EXHIBIT D

**Sherry Jordan
Senior Planner, City of Culver City
Community Development Department, Planning Division
9770 Culver Boulevard
Culver City, California 90232**

**Ref: Technical Memo for the Third Party Review of the Visual Simulations prepared for the
Entrada Office Tower Project**

View Location 3

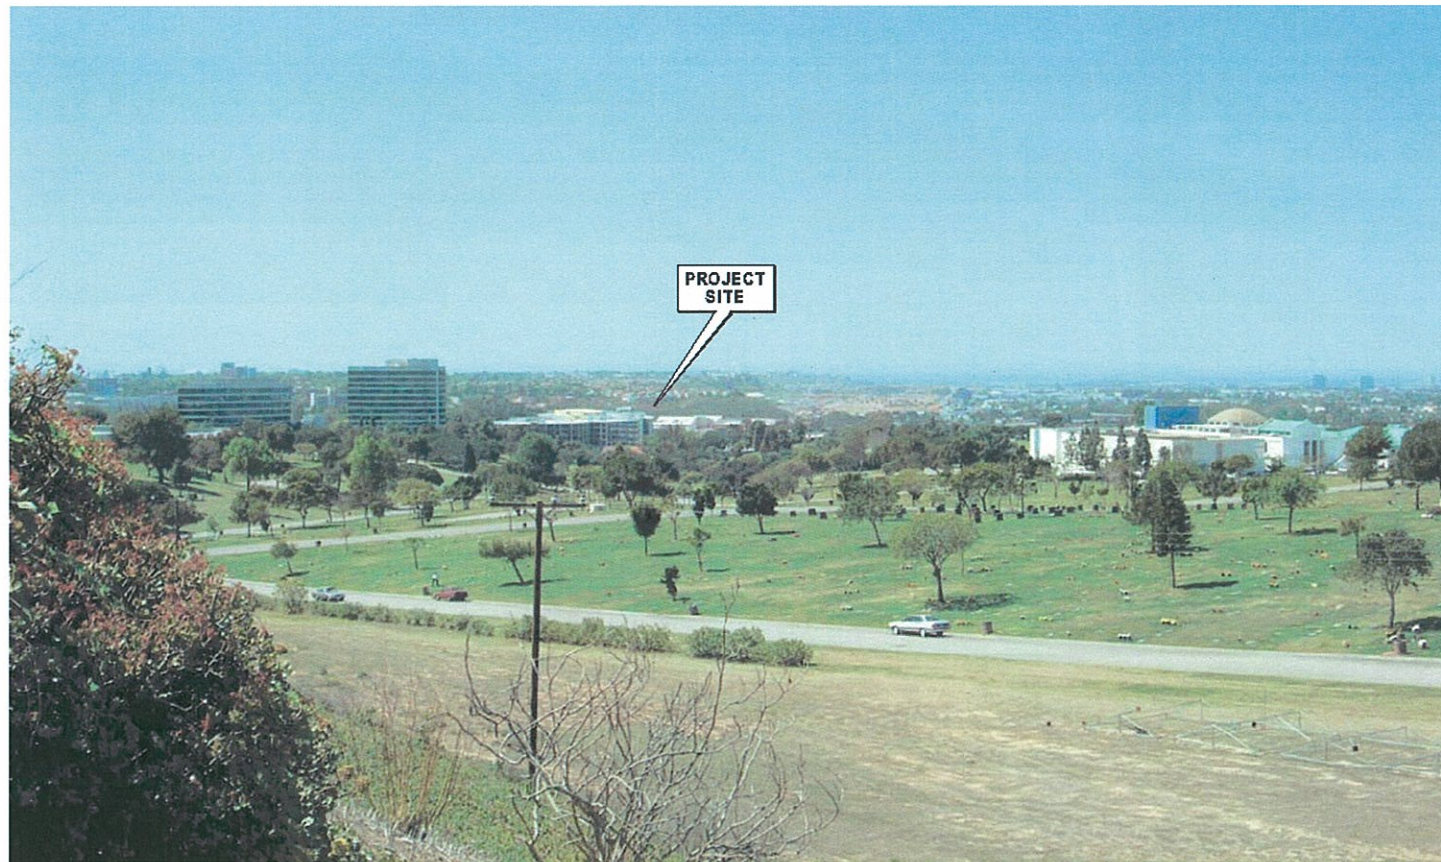
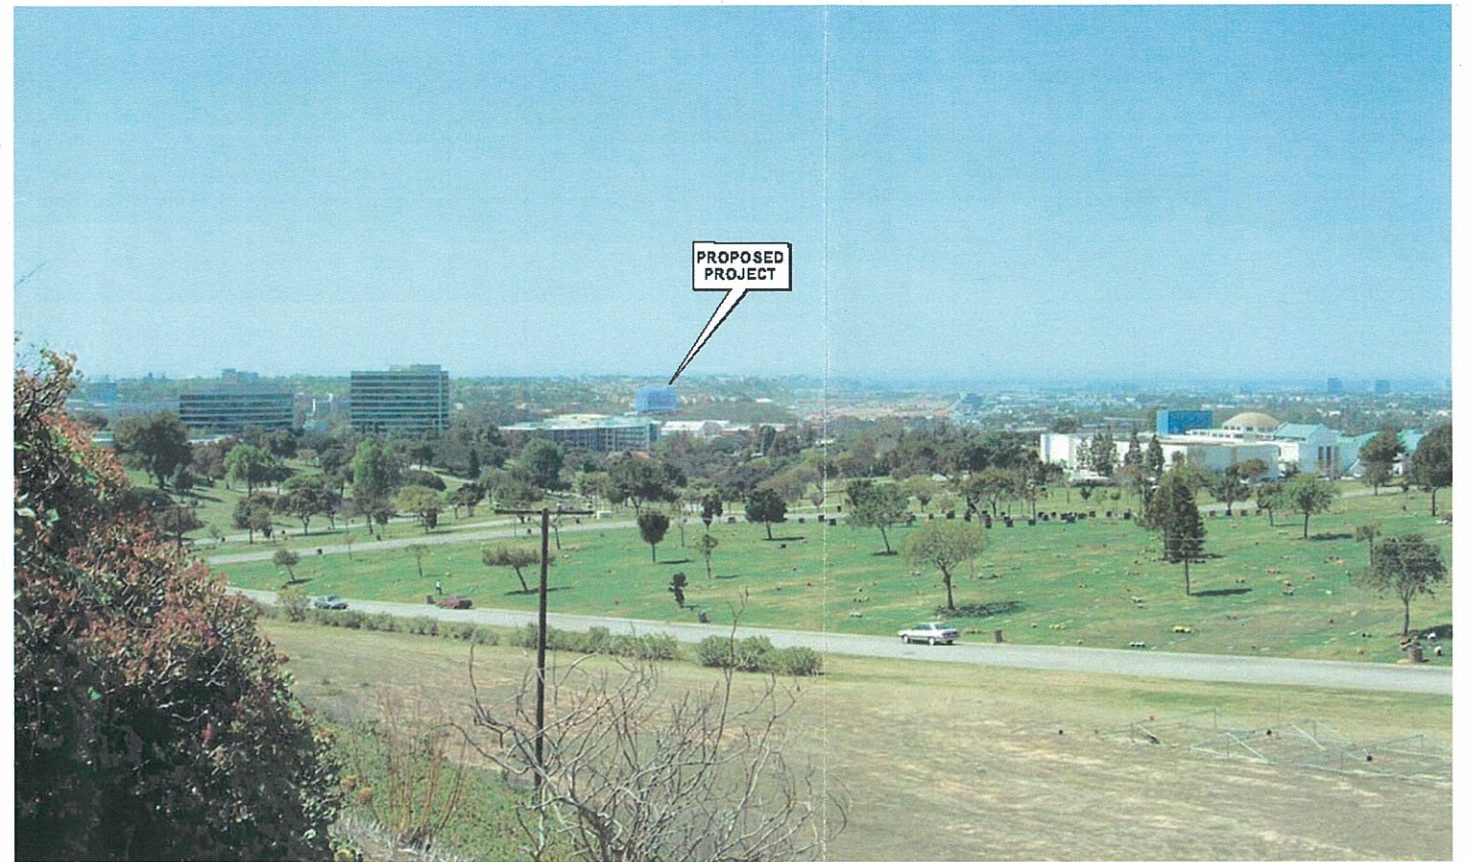
Keyview #3: Adjusted by Gensler for Radisson height change (114.5'); reviewed by KTU+A and indicated the simulation was already accurate and no other adjustments were necessary. **Visual Simulation #3 was previously confirmed by KTU+A to be accurate based on the KTU+A model and keyview location assumptions.**

View Location 4

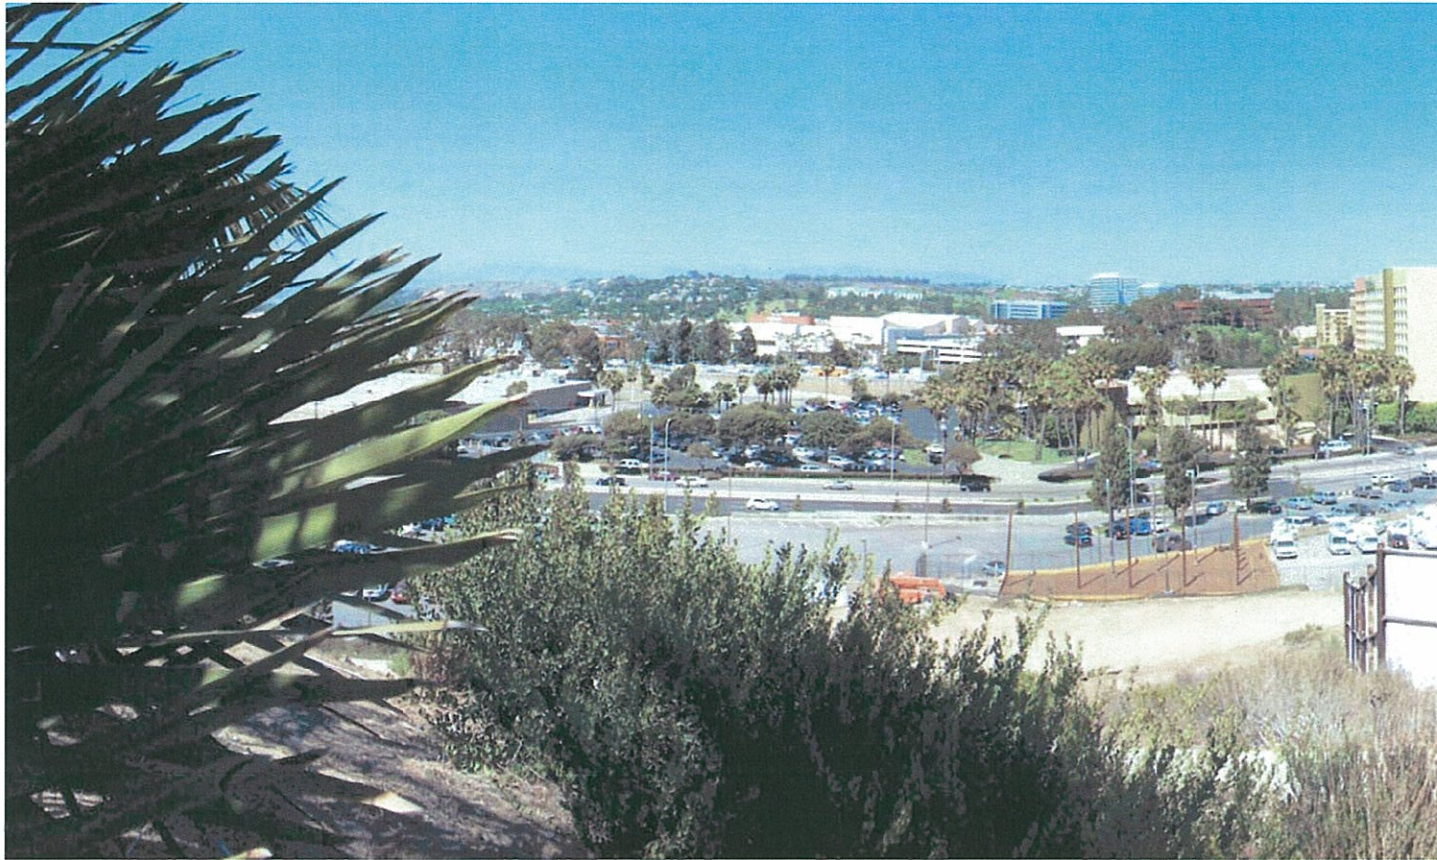
Keyview #4: KTU+A was not able to review the accuracy of this model because of the limits of the KTU+A landform model. Image was too far from the limits of available topographic and mapping coverage. However, the image is very distant and even if adjustments in height or horizontal displacement were similar to those on the other simulations, these adjustments would not show up or have any perceivable change in the simulation; **Visual Simulation #4 not confirmed by KTU+A to be accurate based on limitations in the KTU+A model. However, if adjustments of scale and position were similar to those found in the other simulations, this change would not be perceivable at this distance and would only represent a pixel or two given a 300dpi image resolution.**

View Location 7

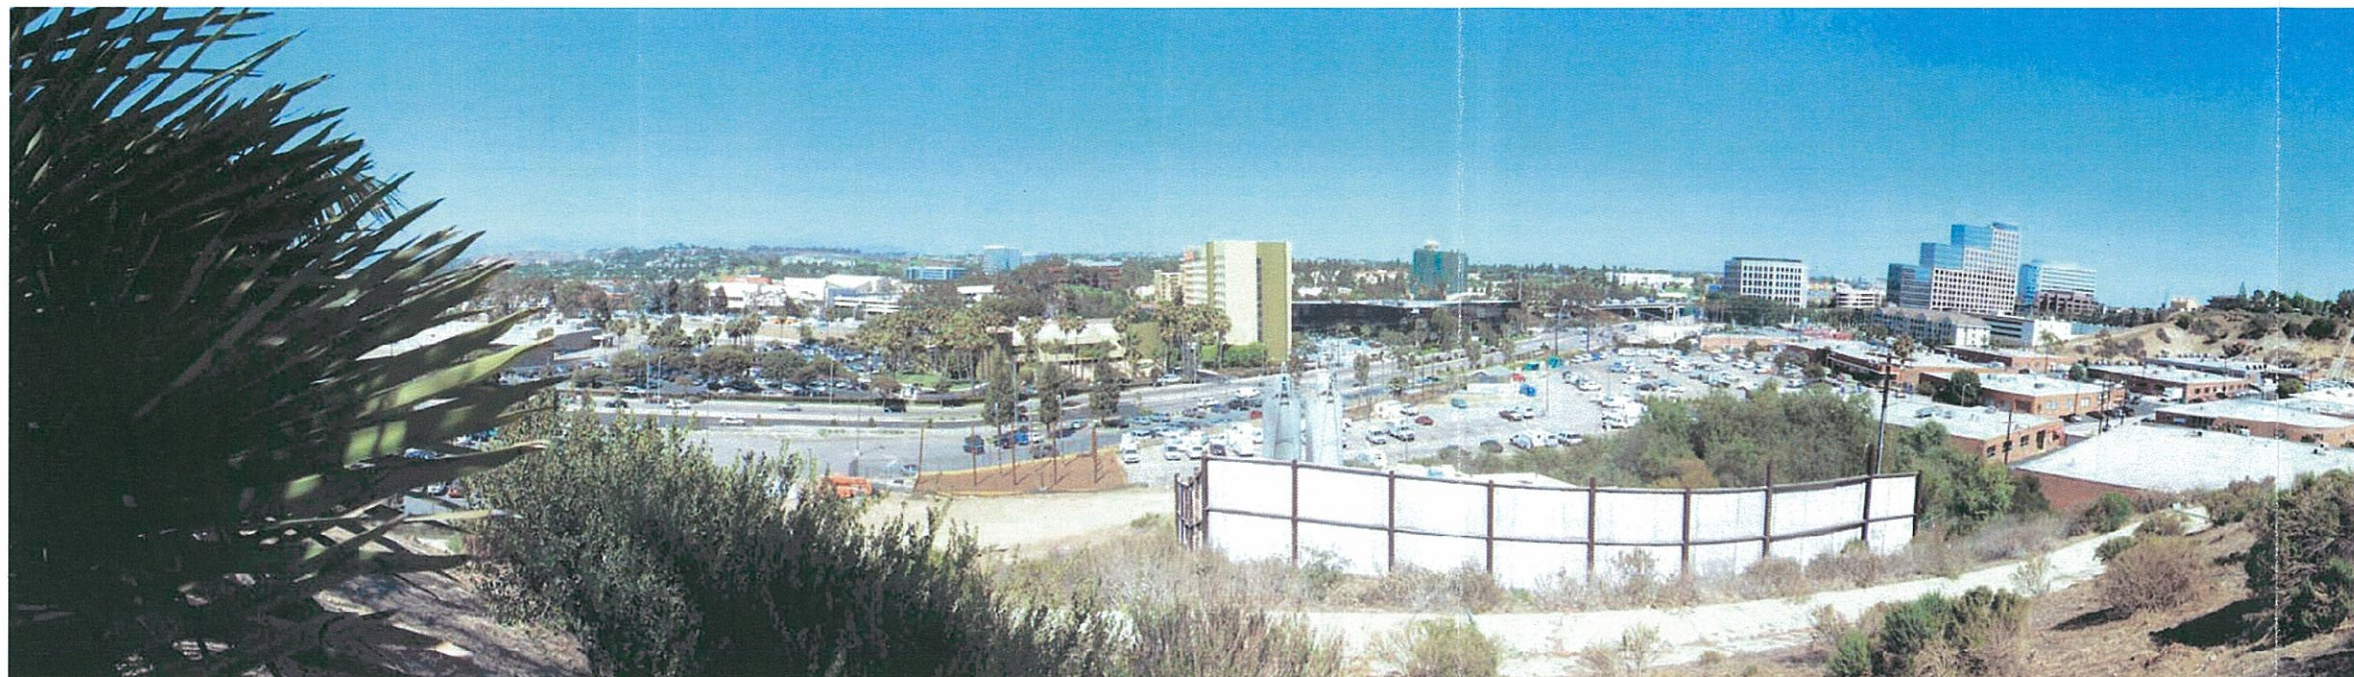
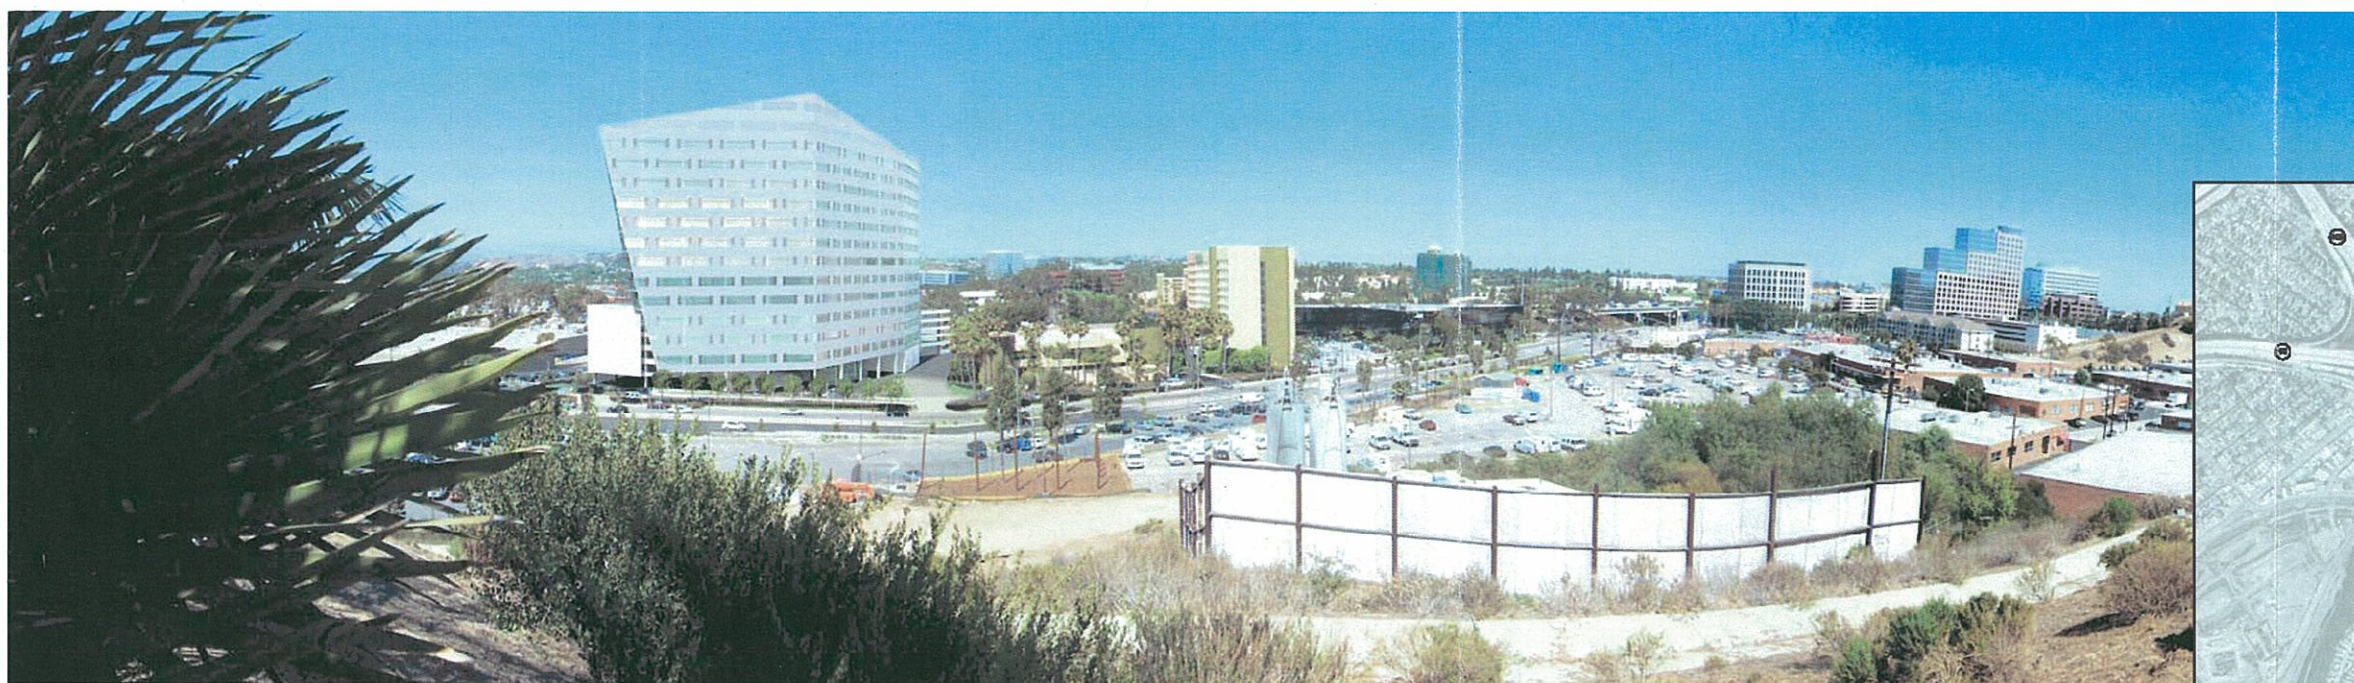
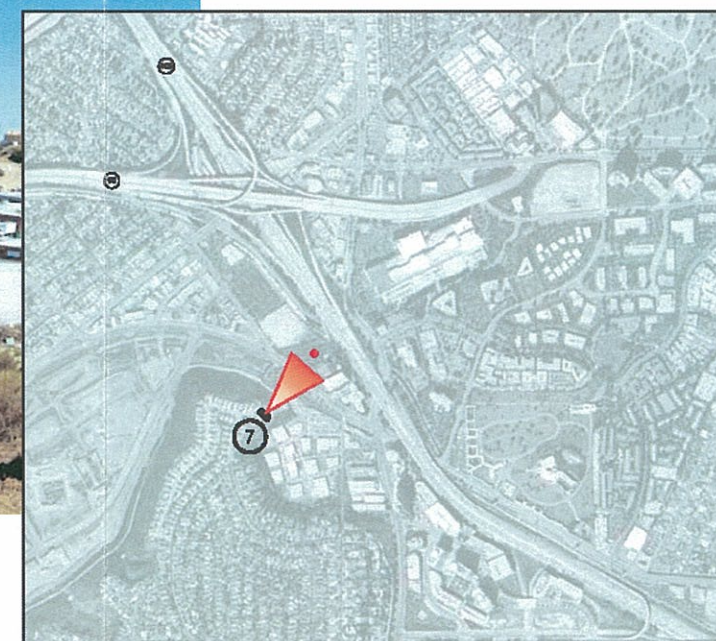
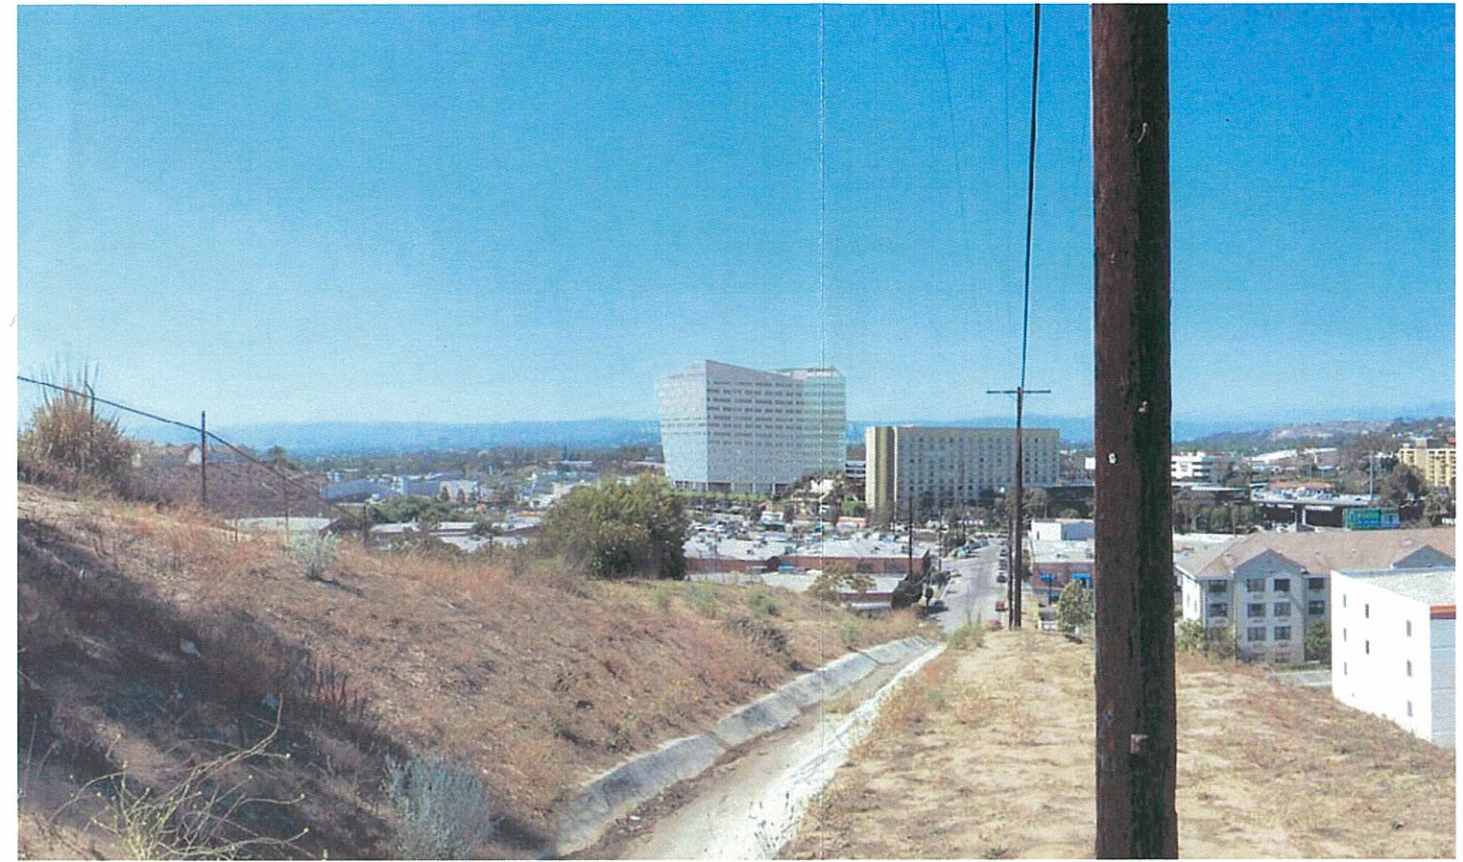
Keyview #7: (Direct and Panoramic): Adjusted by Gensler for Radisson height change (114.5'); reviewed by KTU+A and found that some geometry of scale, rotation and position needed to be adjusted. Gensler corrected

and returned to KTU+A and was not found to match with KTU+A models; a second revision was made to the simulations and verified by KTU+A models. Visual Simulation #7 now confirmed by KTU+A to be reasonably accurate based on the KTU+A model and keyview location assumptions. Some photo distortions still occur in the Panoramic version (and to a lesser extent in the Direct version). The distortion relates to curvatures in the image resulting from stitching together of images and the closer proximity of the project site to this keyview. This distortion does not exist in the new 50mm equivalent version attached to this memo.

Keyview #7: (Normal 50mm): New photograph taken by KTU+A on site with tripod level, GPS coordinates and a lens that would produce a field of view similar to what a normal 50mm uncorrected lens would produce. Visual Simulation #7 supplemented by an additional simulation produced by KTU+A to closer replicate the scale and positioning of what the focused human eye would typically see (not counting expanded view and peripheral vision).
